Re: O3b Limited Response to Commission Questions
IBFS File No. SAT-AMD-20161115-00116 (Call Sign S2935)

O3b Limited (“O3b”) hereby provides the following supplemental information in response to the letter dated March 21, 2017,¹ regarding the above-referenced O3b application.² The text of the questions in the Commission Letter is provided below (with footnotes omitted), followed by O3b’s response for each question.

Annex 2 EPFD ↓ using ITU EPFD validation software and O3b internal software

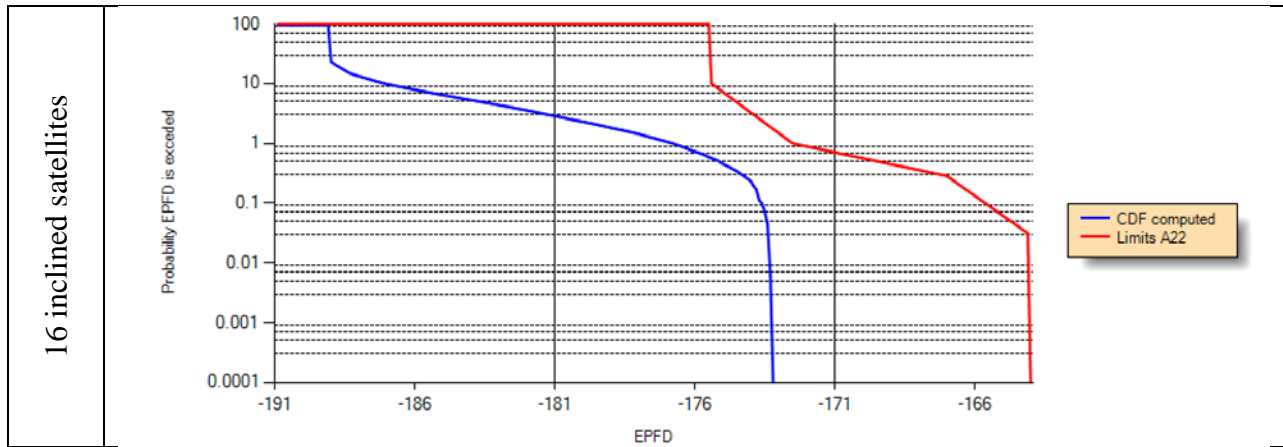
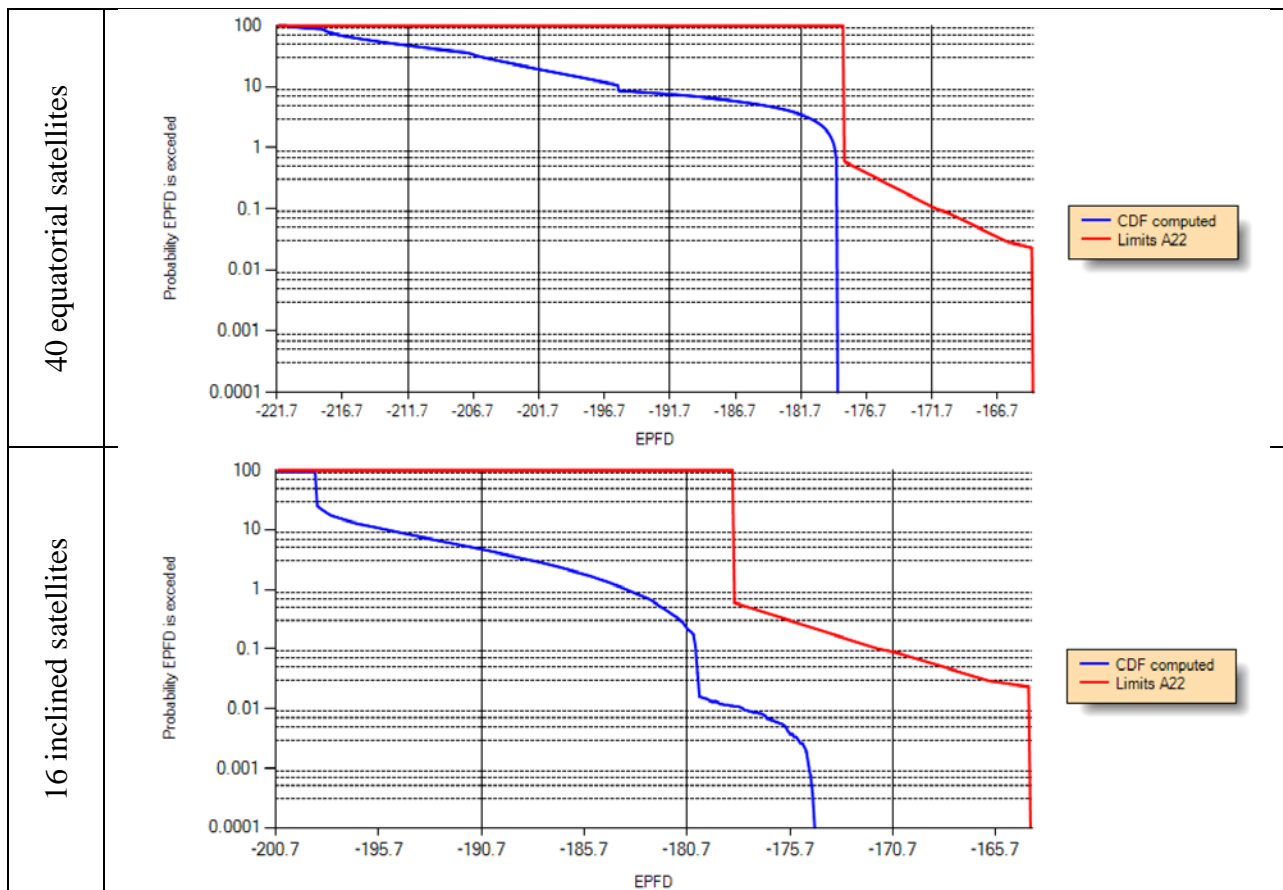
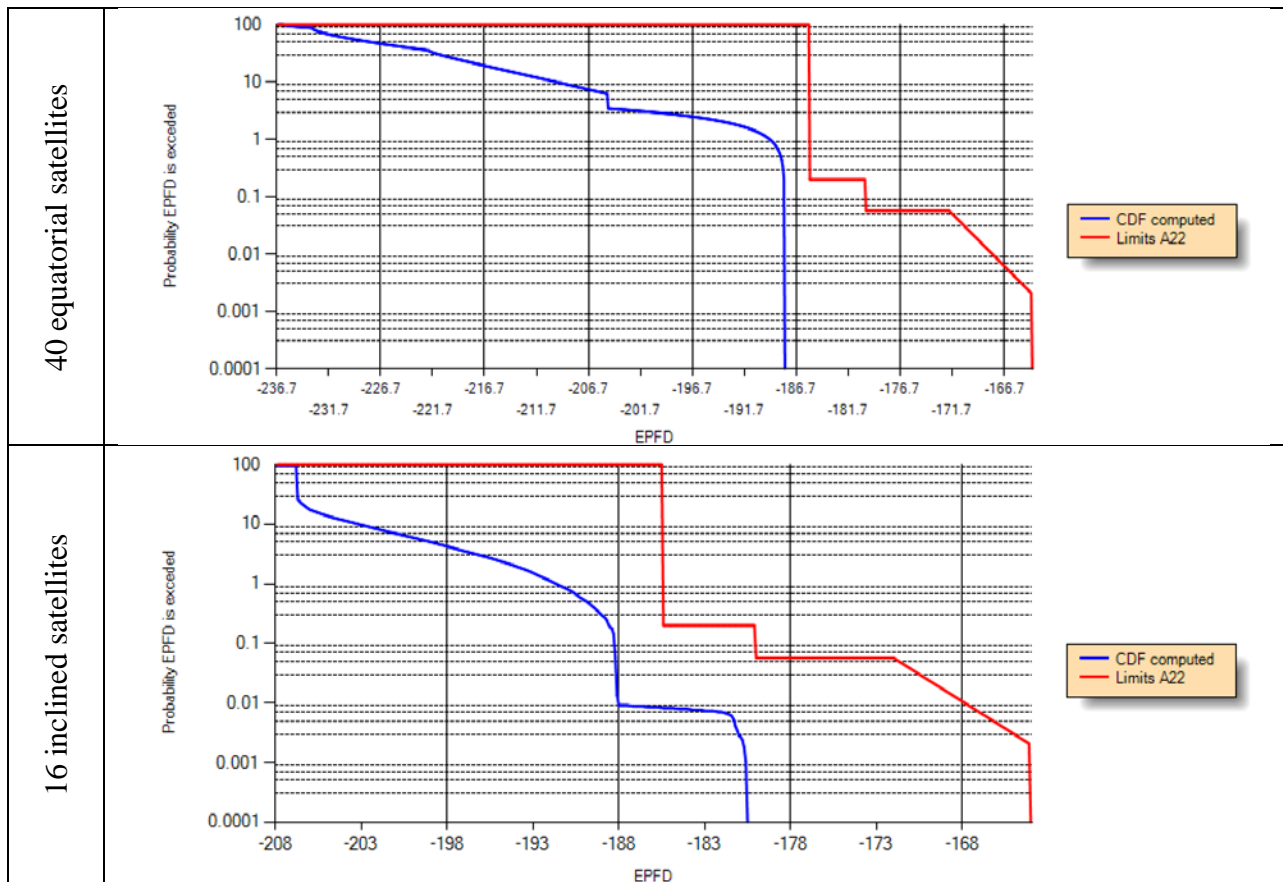
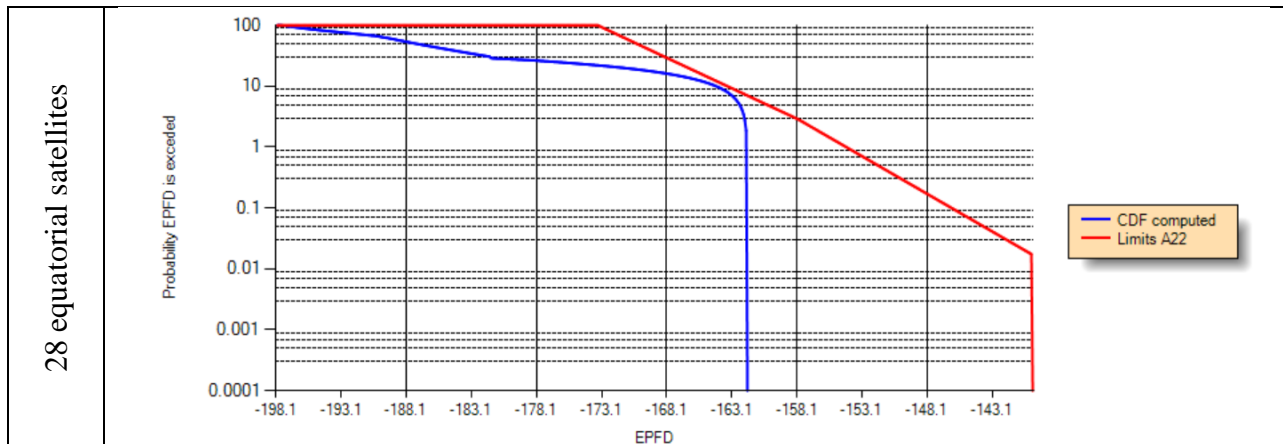
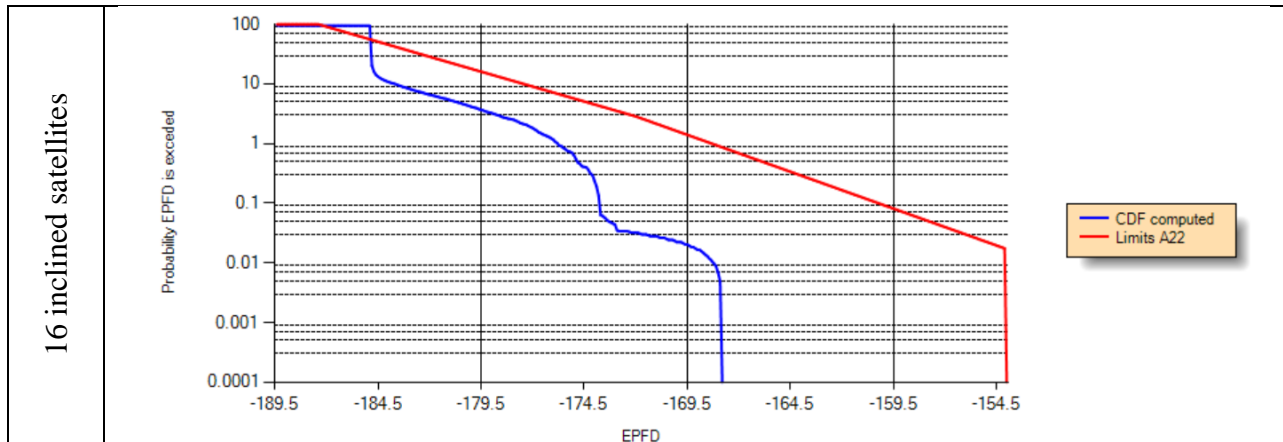
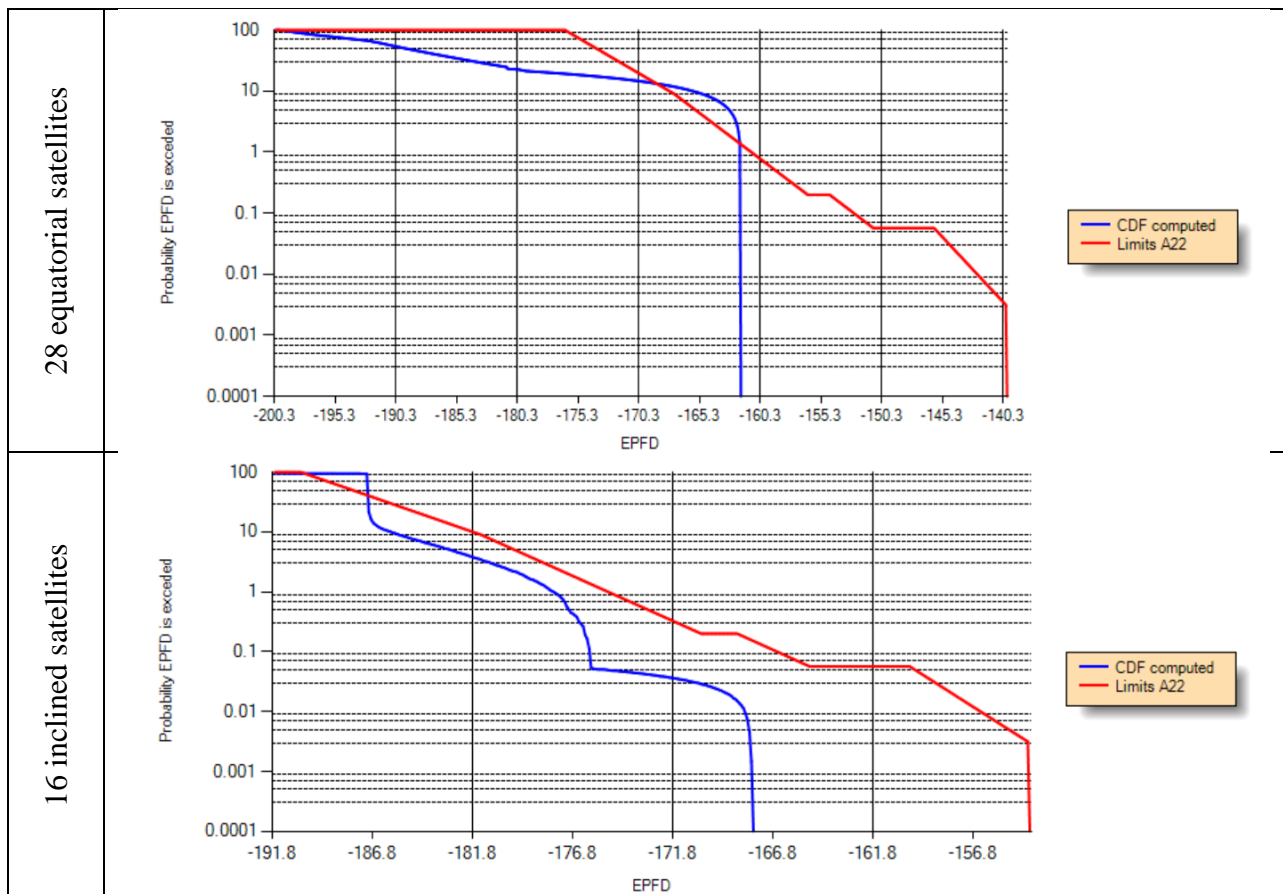
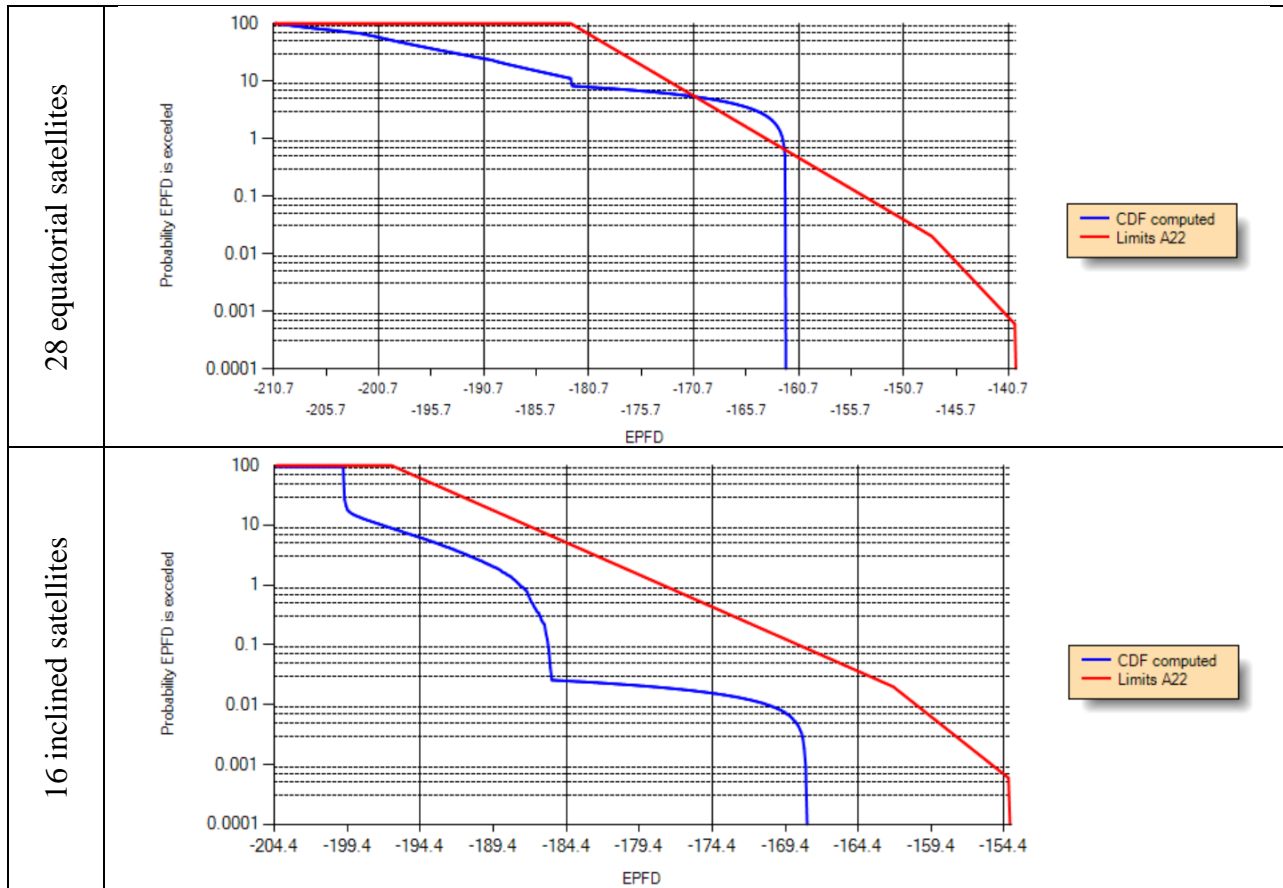
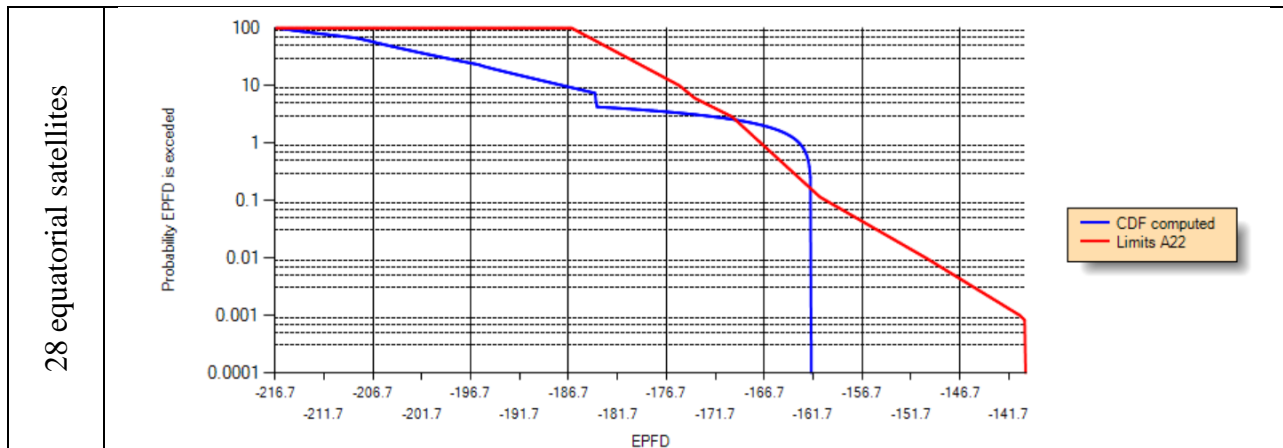
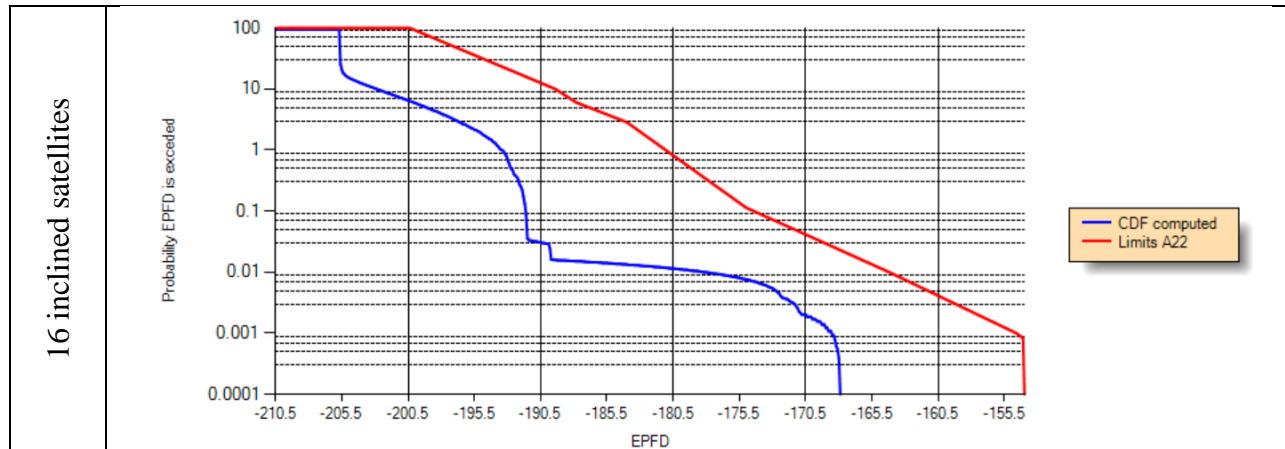
3. Article 22.5I of the ITU Radio Regulations requires NGSO networks to meet the equivalent power flux density (EPFD) limits specified in Articles 22.5C (EPFD ↓), 22.5D (EPFD ↑), and 22.5F (EPFD_{is}) for an NGSO system to fulfill its obligations with respect to geostationary satellite orbit (GSO) networks under Article 22.2. O3b provides, in its interference analysis, a narrative showing that it complies with Articles 22.5C (for the 17.8-18.6 GHz and 19.7-20.2 GHz frequency bands), 22.5D (for the 27.5-28.6 GHz and 29.5-30 GHz frequency bands) and Article 22.5F (for the 17.8-18.4 GHz frequency band). We request that O3b submit, for all these frequency bands, a complete set of PFD masks on the surface of the Earth for each of the 56 active space stations in its NGSO FSS system, and a complete set of NGSO FSS earth station EIRP masks as a function of the off-axis angle generated by the NGSO FSS earth station, which are required to run the ITU-R Recommendation S.1503 EPFD Validation Software. Please also supplement the amendment to include the output data files from the ITU EPFD Validation Software, and/or corresponding plots of the computed EPFD levels for the 56 active satellite constellation compared to the EPFD masks for each of the reference GSO and/or BSS earth station antennas.

Annex 2 shows the calculation output for the EPFD \downarrow levels using both the ITU software and the O3b proprietary software.

The first set of plots below show the EPFD ↓ results for the 17.8-18.6 GHz and 19.7-20.2 GHz frequencies using the ITU validation software. The results are shown for each reference antenna size from Article 22 for these frequencies. Since the number of O3b satellites with the frequency bands 17.8-18.6 GHz and 19.7-20.2 GHz varies, different configurations were analyzed separately. Next to each figure, the configuration corresponding to the chart is listed.

As seen in the above figures for the 19.7-20.2 GHz downlink EPFD evaluations, the results from the ITU software suggest that the applicable ITU limits are exceeded for the 0.9-meter, 2.5-meter and 5-meter antenna diameters in the equatorial configuration and for the 0.7-meter and 0.9-meter antenna diameters in the inclined configuration. This is due to the ITU software’s inability to model certain types of steerable beams.
